Duke Energy Corporation

SUBJECT: Duke Energy Corporation (DEC)
McGuire Nuclear Station Units 1 and 2
Docket Nos. 50-369/50-370

Proposed Technical Specification Amendment
TS 5.5.11 - Ventilation Filter Testing Program

PROPOSED REVISIONS TO THE MCGUIRE NUCLEAR STATION TECHNICAL SPECIFICATIONS

5.5.11 Ventilation Filter Testing Program (VFTP) (continued)

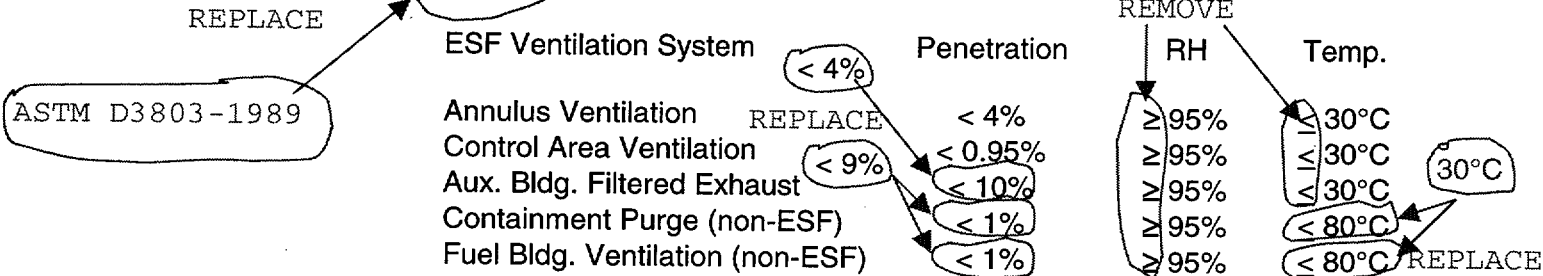
c. Demonstrate for each of the ESF systems that a laboratory test of a sample of the charcoal adsorber, when obtained as described in Regulatory Guide 1.52, Revision 2, shows the methyl iodide penetration less than the value specified below when tested in accordance with ASTM D3803-1979 (ASTM D3803-1989 for Annulus and Control Area Systems) at the temperature and relative humidity (RH) specified below.

ESF Ventilation System	Penetration	RH	Temp.
Annulus Ventilation	< 4%	$\geq 95\%$	$\leq 30^\circ\text{C}$
Control Area Ventilation	< 0.95%	$\geq 95\%$	$\leq 30^\circ\text{C}$
Aux. Bldg. Filtered Exhaust	< 10%	$\geq 95\%$	$\leq 30^\circ\text{C}$
Containment Purge (non-ESF)	< 1%	$\geq 95\%$	< 80°C
Fuel Bldg. Ventilation (non-ESF)	< 1%	$\geq 95\%$	< 80°C

1. The first paragraph of Technical Specification 5.5.11, Section c, would be revised to remove the phrase

"..tested in accordance with ASTM D3803-1979 (ASTM D3803-1989 for Annulus and Control Area Systems) at the temperature and relative humidity (RH) specified below."

2. The penetration value shown in Technical Specification 5.5.11, Section c, for the VA, VP, and VF systems would be revised to < 4%, < 9%, and < 9%, respectively.
3. The test temperature and relative humidity for the systems shown in Technical Specification 5.5.11, Section c, would be revised to 30°C and 95%, respectively.

- c. Demonstrate for each of the ESF systems that a laboratory test of a sample of the charcoal adsorber, when obtained as described in Regulatory Guide 1.52, Revision 2, shows the methyl iodide penetration less than the value specified below when tested in accordance with ASTM D3803-1989 at the temperature and relative humidity (RH) specified below.

ESF Ventilation System	Penetration	RH	Temp.
Annulus Ventilation	< 4%	95%	30°C
Control Area Ventilation	< 0.95%	95%	30°C
Aux. Bldg. Filtered Exhaust	< 4%	95%	30°C
Containment Purge (non-ESF)	< 9%	95%	30°C
Fuel Bldg. Ventilation (non-ESF)	< 9%	95%	30°C

"..tested in accordance with ASTM D3803-1989 at the temperature and relative humidity (RH) specified below."
